Consolidated Q&As from Gowanus Canal CAG

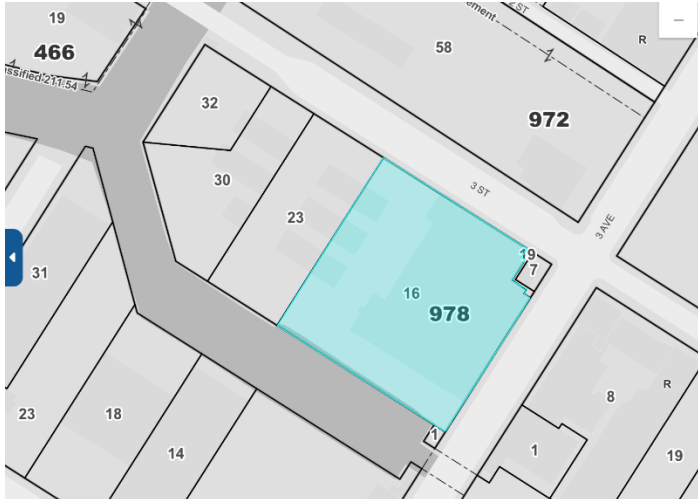
Follow up question:

Although the answer to this question was "yes", the information below and your answer to # 3 below is not reassuring (see below, question 3 is included for your reference). It appears that the area of the parking lot that was owned by The Crushers was not entered under the Brownfields Program. Attached is the easement document the NYSDEC placed on the property

following the BCP work. It covers the lots 16-1 on block 978, *but not lots 23, 30, or 32. There is no evidence that Lots 23,30,32 were ever in the DEC Brownfield Cleanup Program.*

As far as our committee members recall, the cleanup work on Lots 1-16 was for the removal of septic tanks on the site. Was testing done for other contaminants? If so: Which ones? What were the results? Was the site remediated for such contaminants?

Thus, our question regarding recontamination stands.

EPA reviewed the information at the time and had no issue with those properties. Not every parcel has sufficient contamination to qualify for the brownfields program. Please seek additional information from DEC.
